Access Compliance Report

Public Rights-of-Way

(Curb Ramps)

Intersection ID: 8445	Main Street: IRMA_ST	Cross Street: LASALLE_ST	Location: SE
ADA ID: 4EFA28A10DAD	Ramp Type: PerpDiag	Initial Pass/Fail: Fail	Overall Compliance: No
		Severity Score: 35

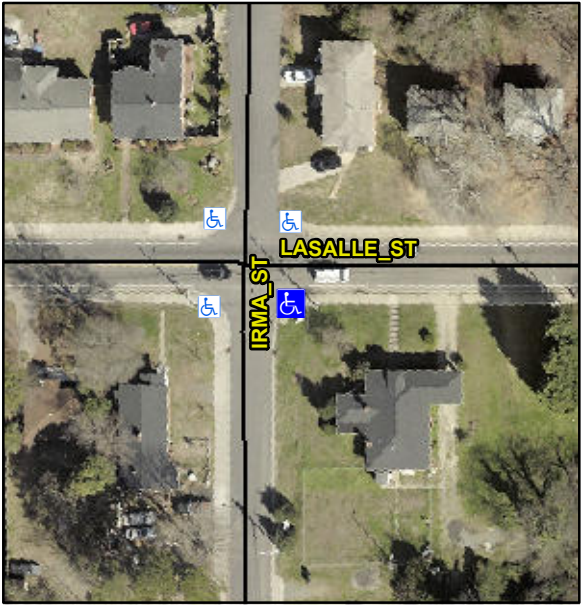
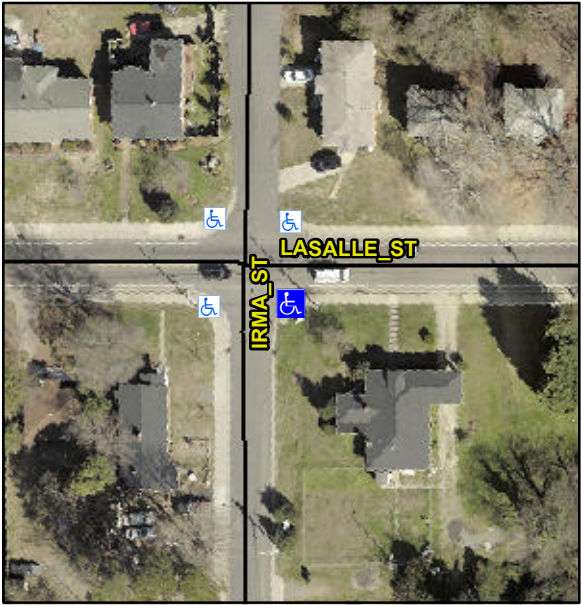
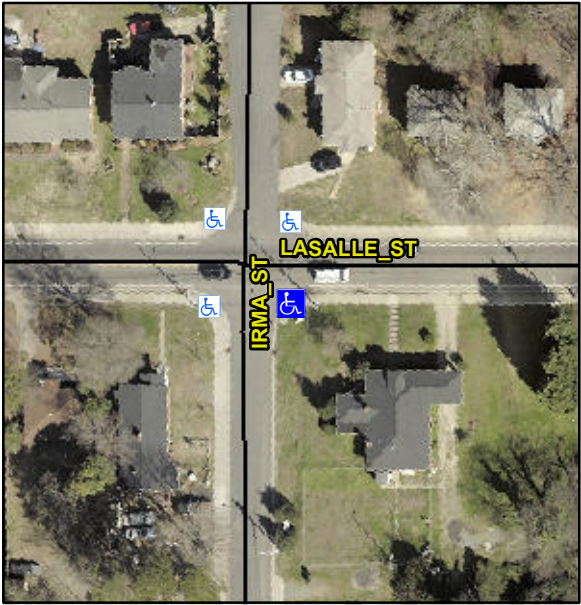
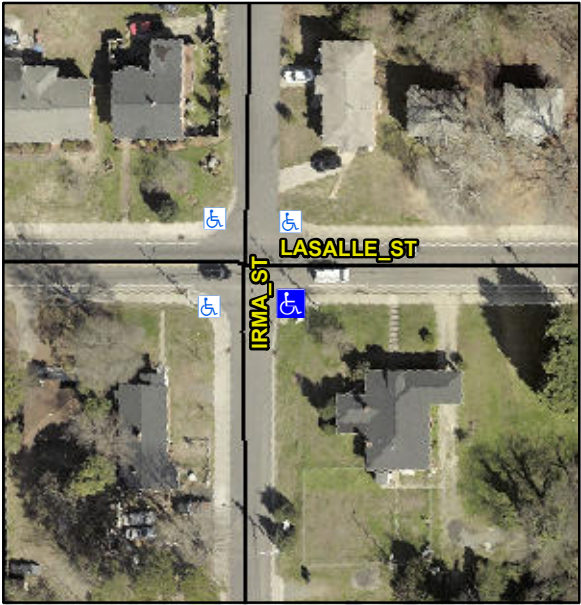
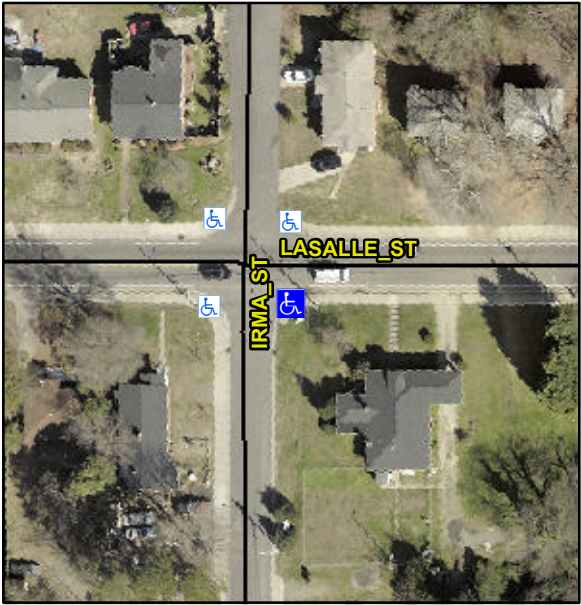
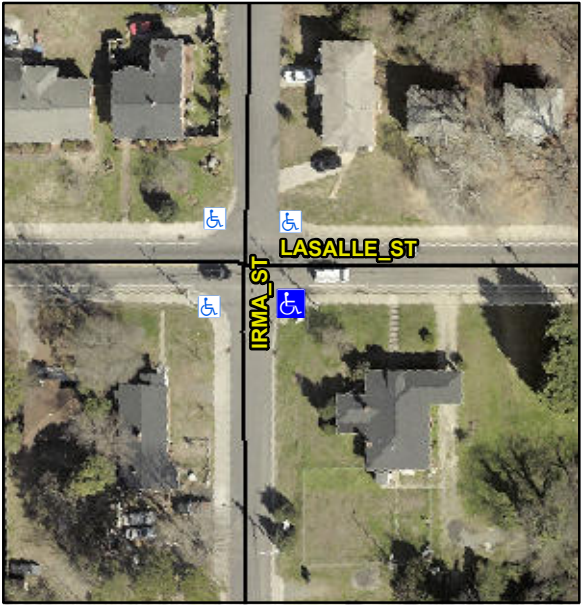
Codes/Mitigation Info/Possible Solution			Field Measurements/Component Compliance		
	Possible Solutions:		Compliance	Description	Data
	Remove & Replace Curb Ramp With Two New Directional Ramps or Equivalent.		Compliance	Description	Data
	Surveyor Notes:		N/A	Ramp Length (in)	61.0
	N/A		No	Ramp Width (in)	36.5
	PROW/ADA:		N/A	Flare Type LT	N/A
	Not Found, R304.5.1, R304.2.2, R304.5.3		N/A	Flare Slope LT (%)	N/A
			N/A	Flare Traversable LT?	N/A
			N/A	Flare Slope RT (%)	N/A
			N/A	Flare Traversable RT?	N/A
			N/A	DWS Provided?	N/A
			N/A	DWS Contrast?	N/A
			N/A	DWS Length (in)	N/A
			N/A	DWS Full Width?	N/A
			N/A	DWS Offset (in)	N/A
			N/A	Gutter Ponding?	N/A
			N/A	Gutter Lip Ht (in)	N/A
			N/A	Painted X Walk1?	No
				X Walk 1 Direction	To N
			N/A	X Walk 1 Width (in)	N/A
				X Walk 1 Slope (%)	2.8
				X Walk 1 X Slope (%)	0.6
				X Walk 2 Direction	To W
			N/A	X Walk 2 Width (in)	N/A
				X Walk 2 Slope (%)	1.1

X Walk 2 X Slope (%)	3.8
			N/A	Ramp inside XWalk1?	N/A
			N/A	Ramp inside XWalk2?	N/A
				Road Slope (%)	1.8
				Clear Space?	N/A
				Clear Space to XWalk (in)	N/A
			N/A	Storm Grate/Utility Hazard?	N/A
				Storm Grate/Utility Type	
			N/A		N/A
			Yes	Surface Condition? (G/P)	Good
